# THE VILLAS AT CLAREMONT RANCH

## CONSTRUCTION DRAWINGS

### STREET IMPROVEMENTS PLANS

## STORM SEWER PLANS

THE VILLAS AT CLAREMONT RANCH		SCALE: N/A	DATE: 07/29/22
		JOB NUMBER: 16-102	SHEET: 4 OF 4

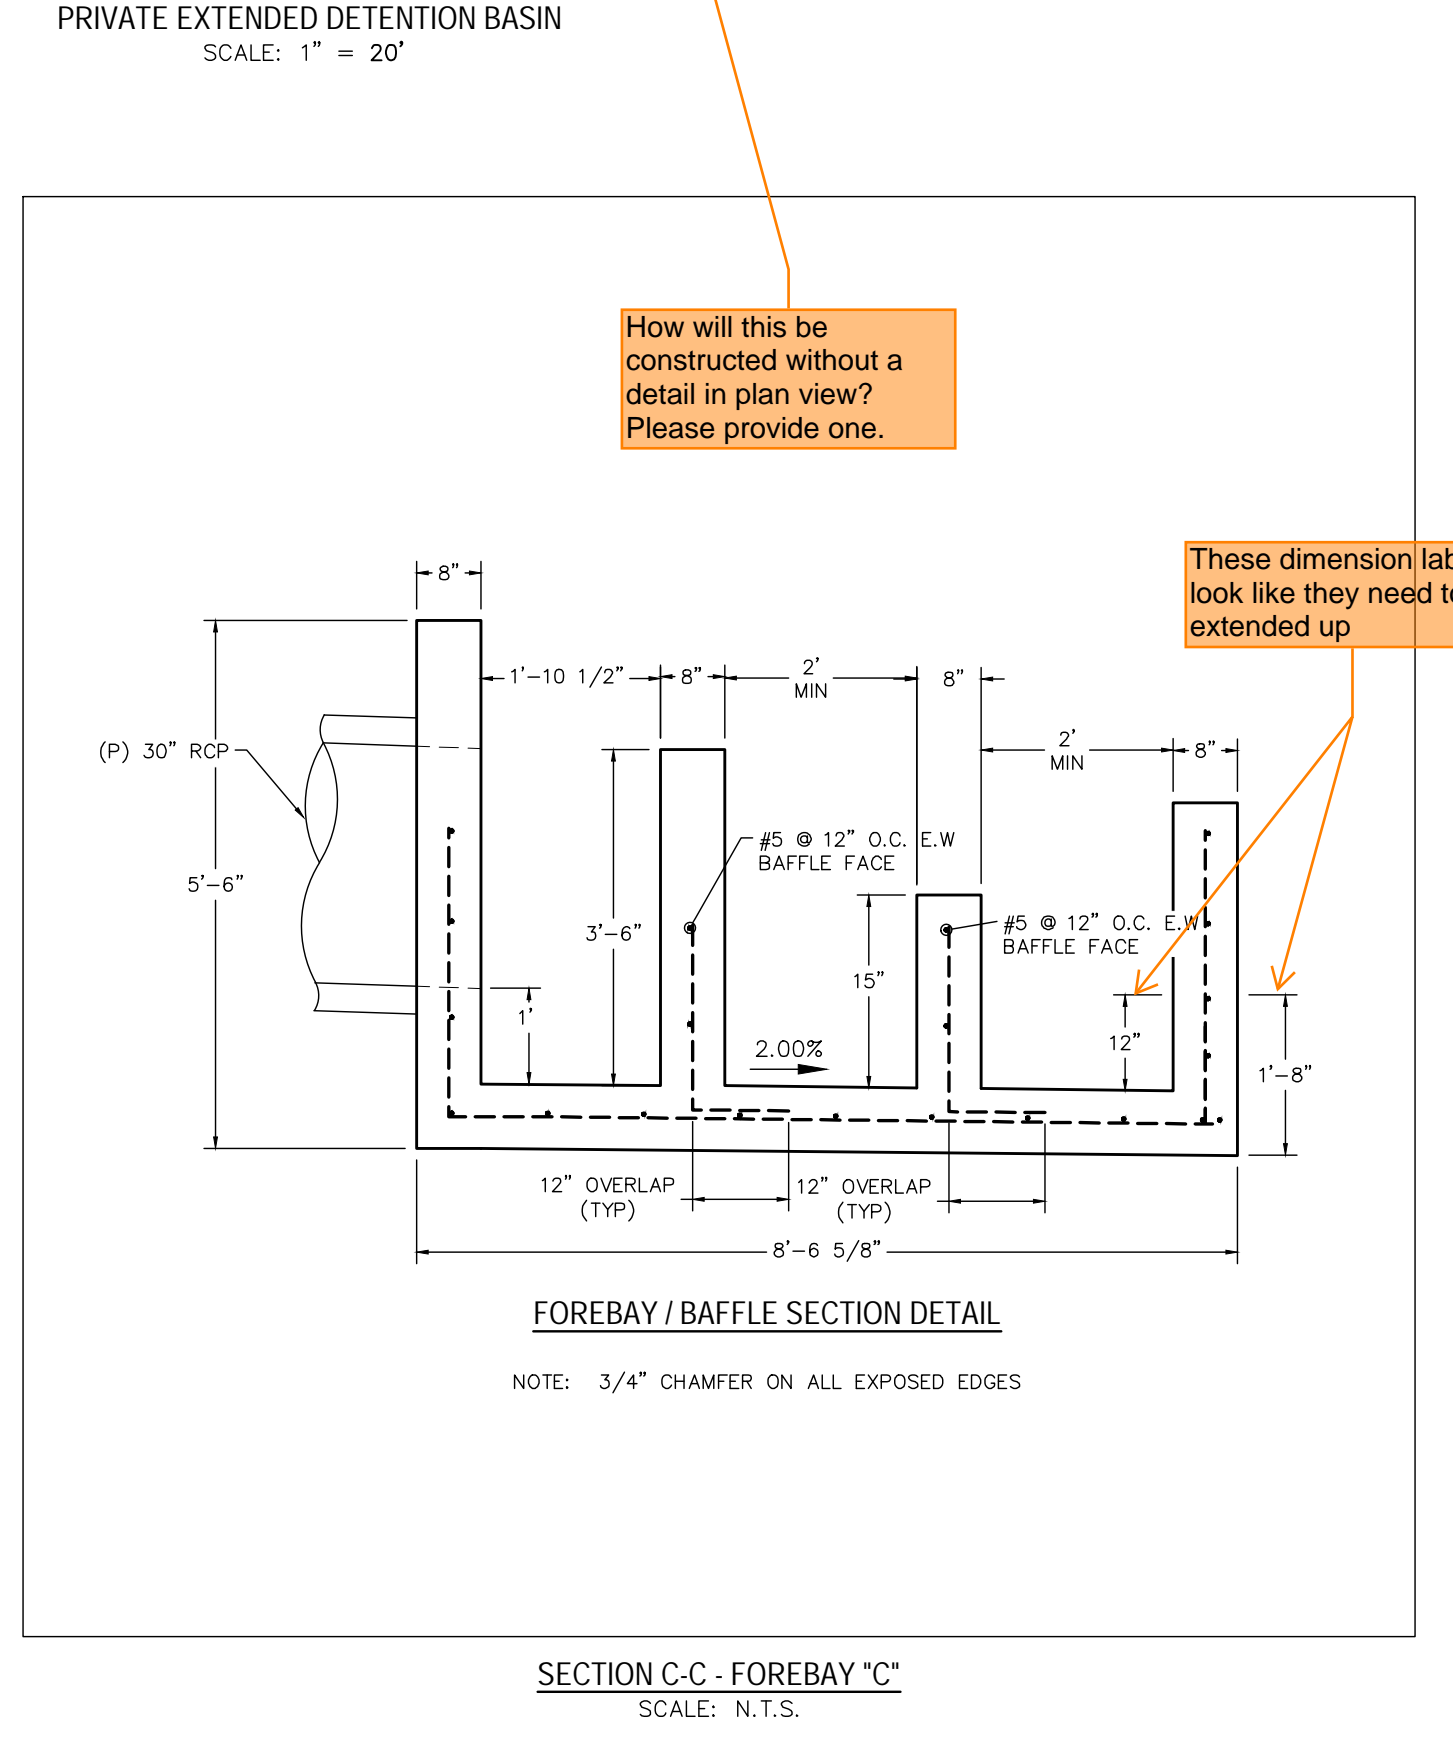
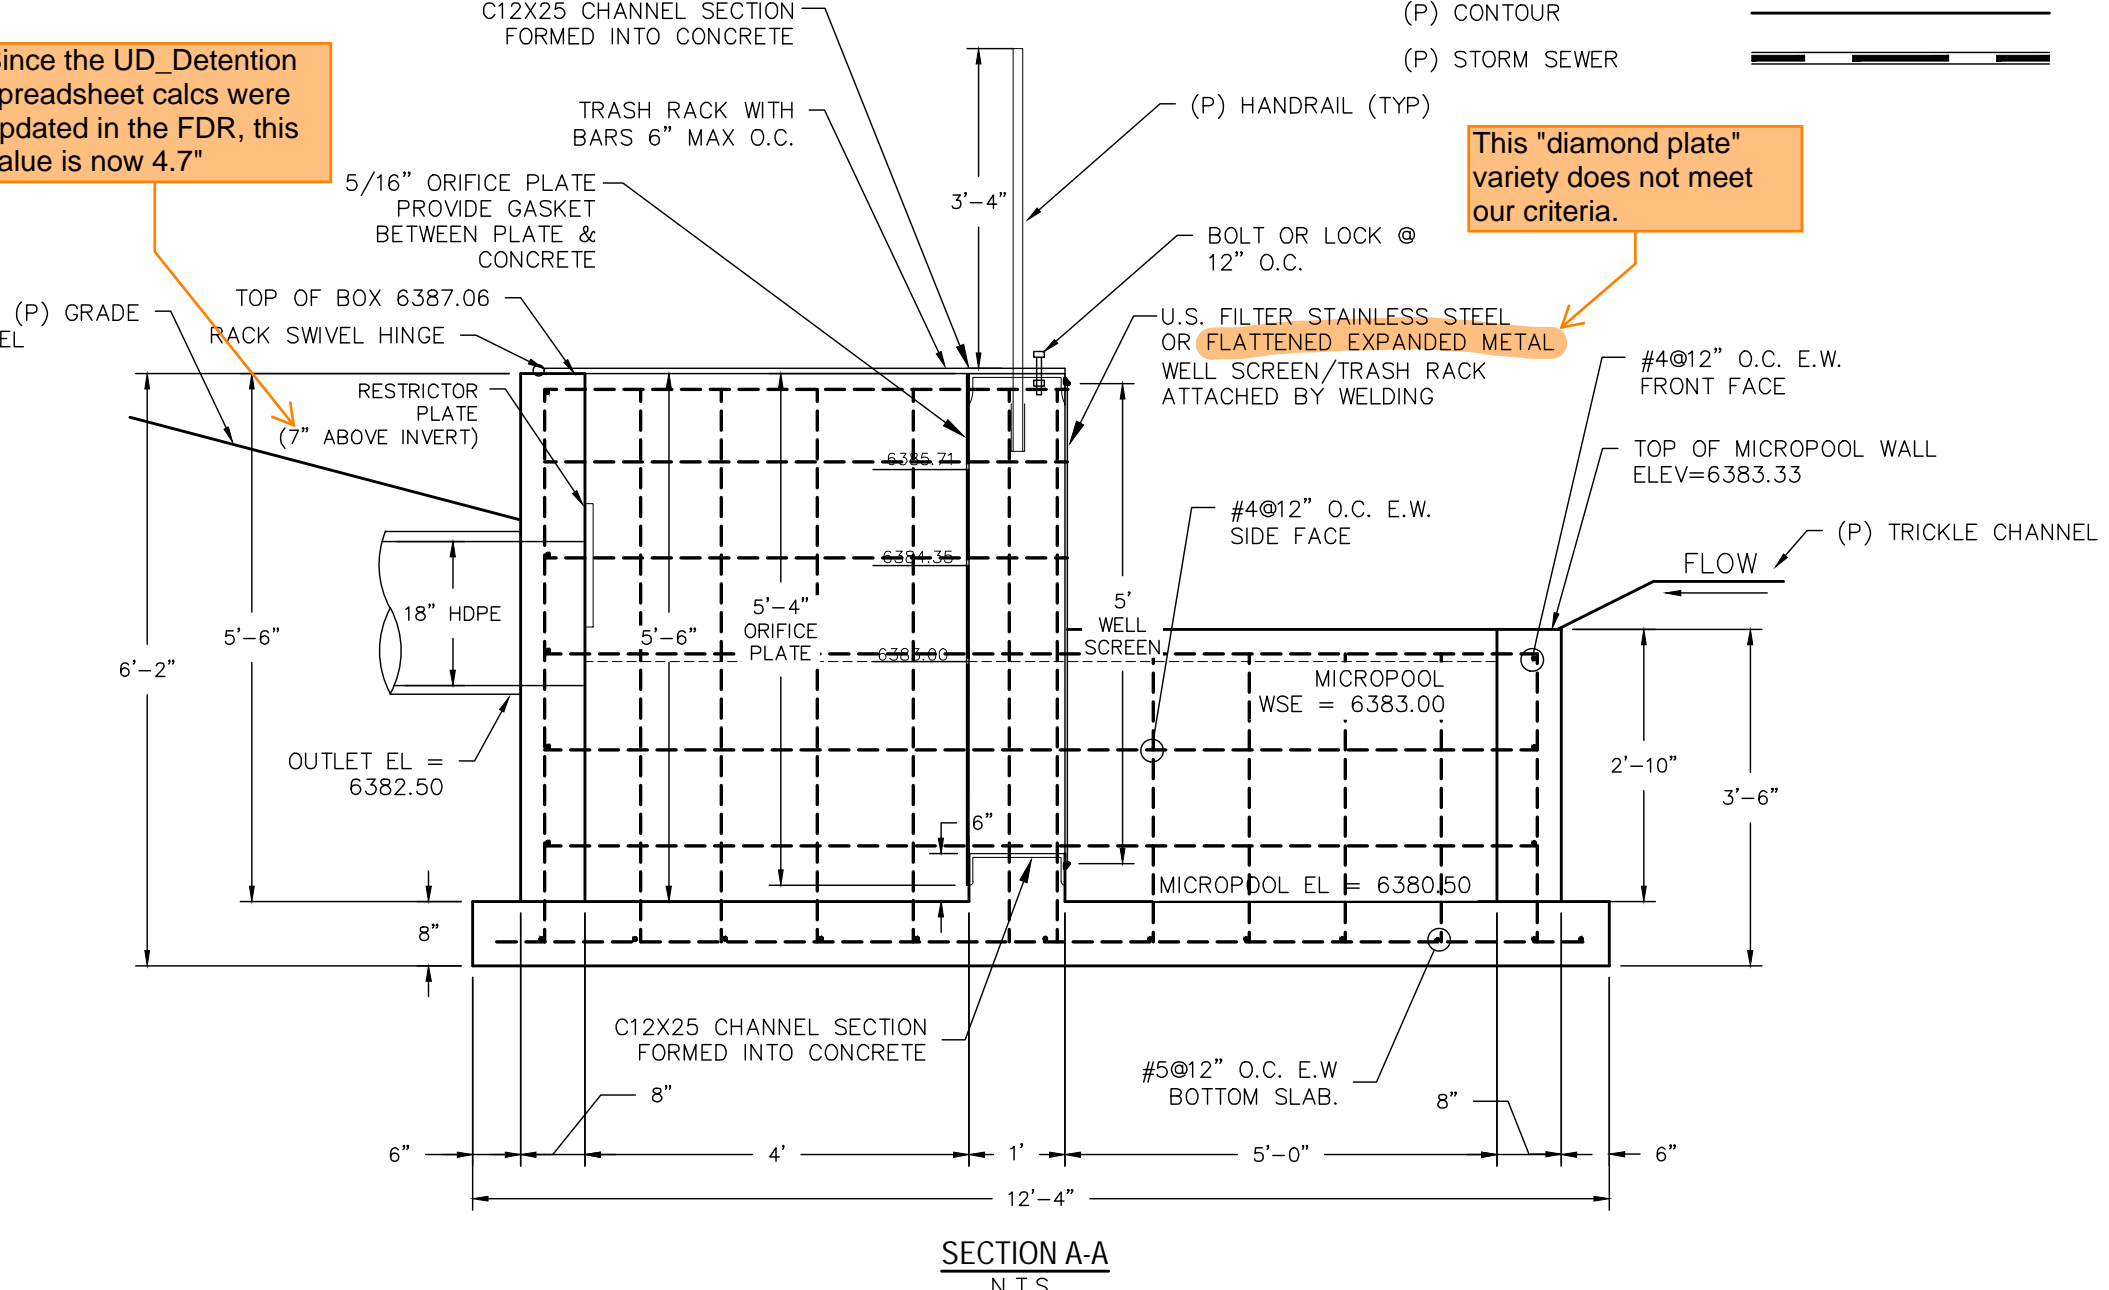
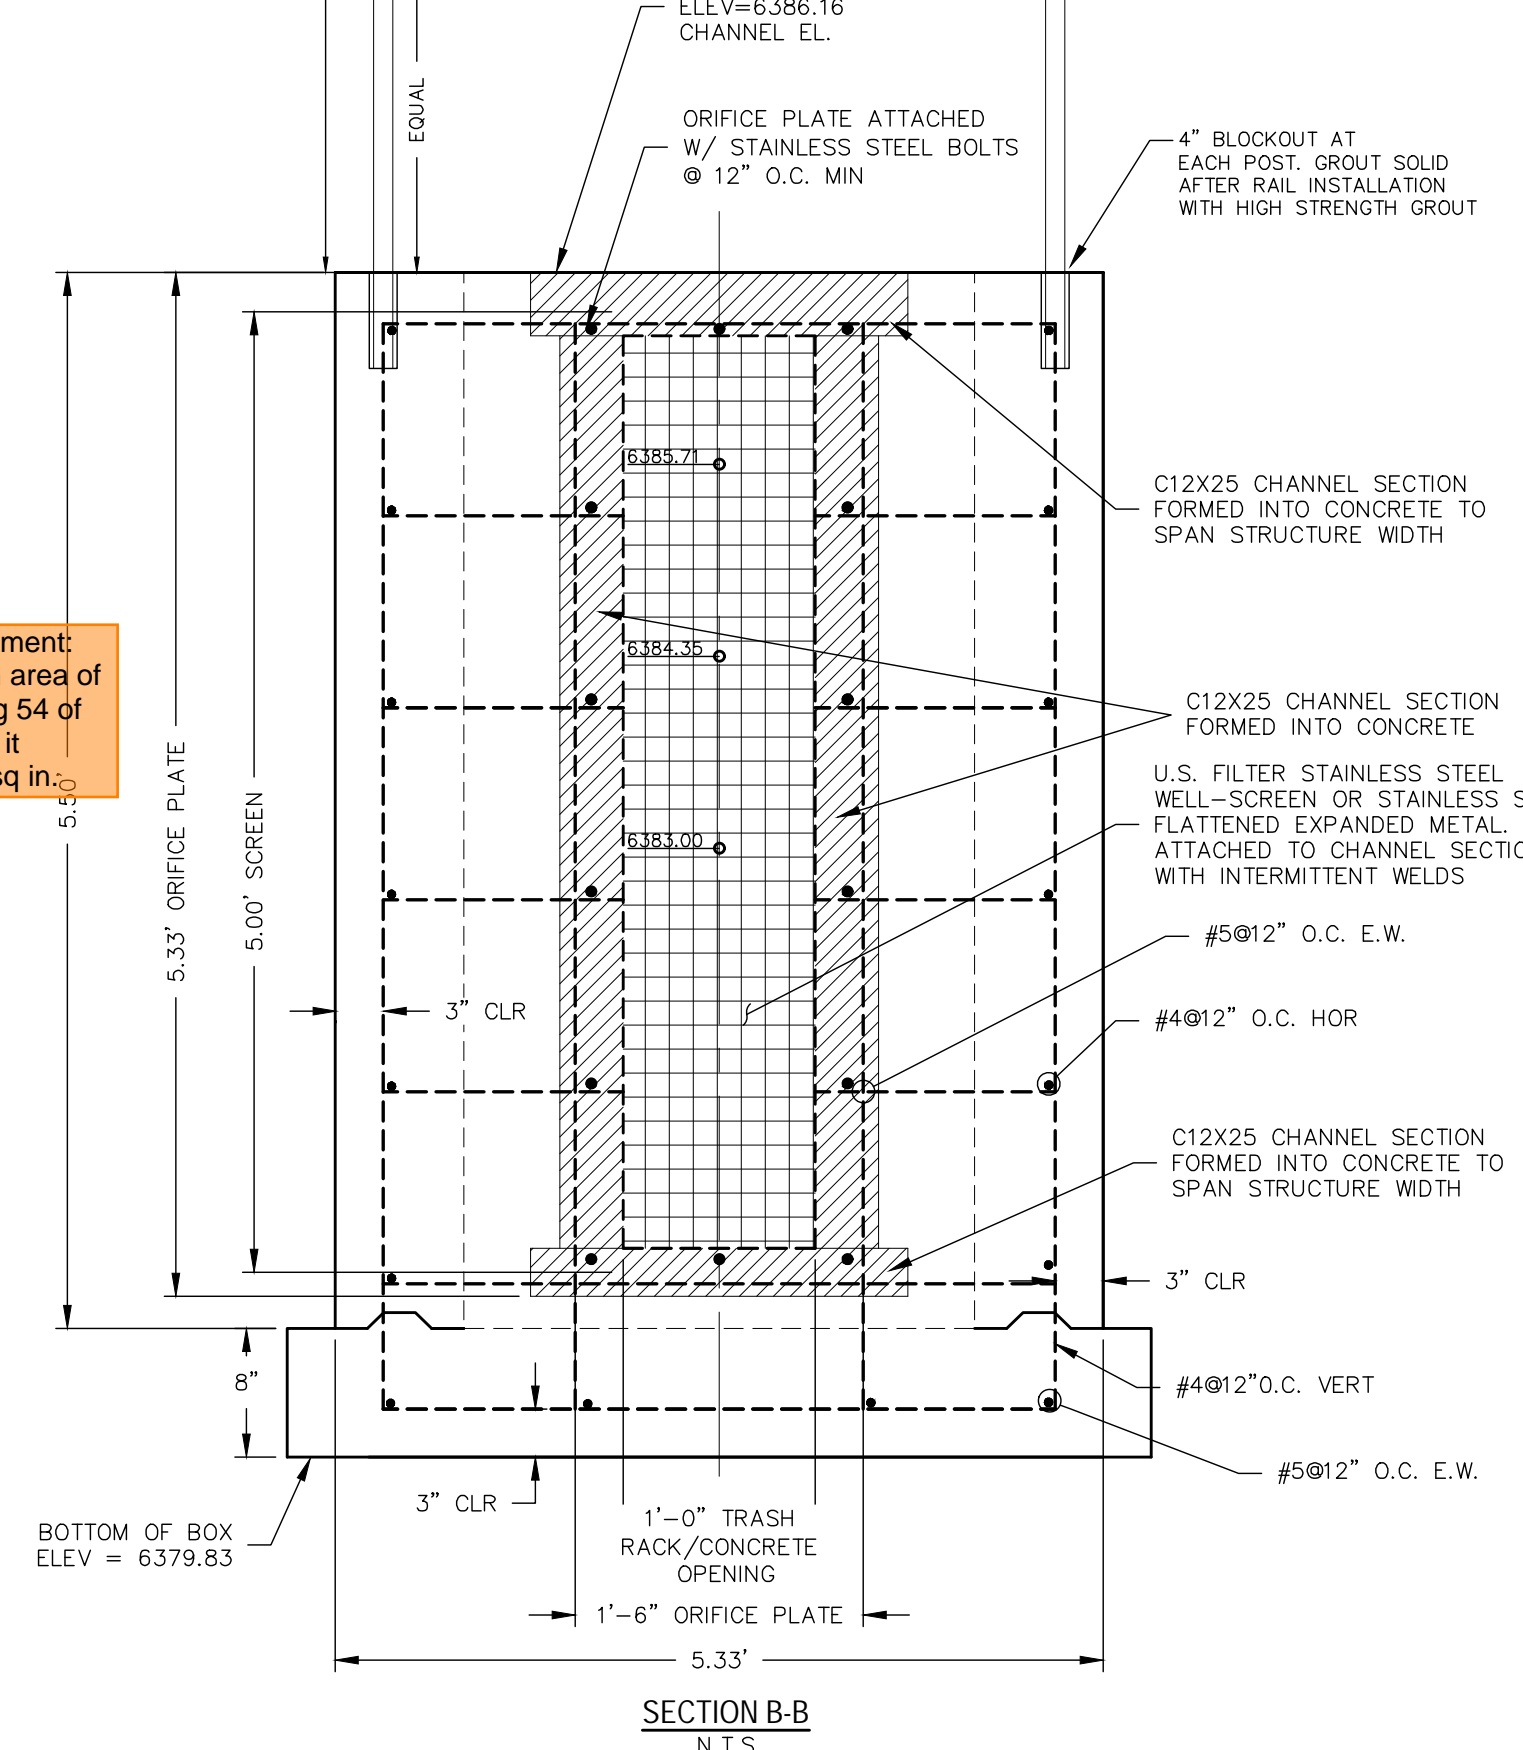
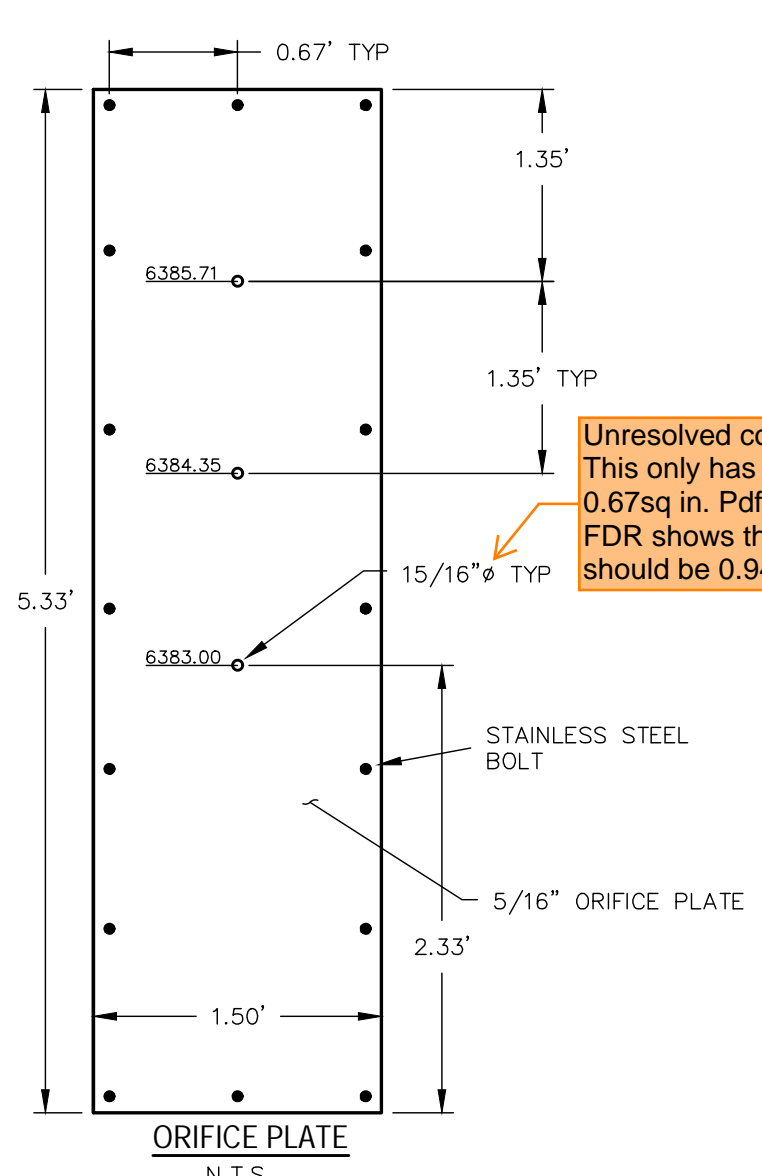
Provide details for: trickle channel, access road, handrail

Shouldn't these elevations match?

Since the UD Detention spreadsheet calcs were updated in the FDR, this value is now 4.7'

How will this be constructed without a detail in plan view? Please provide one.
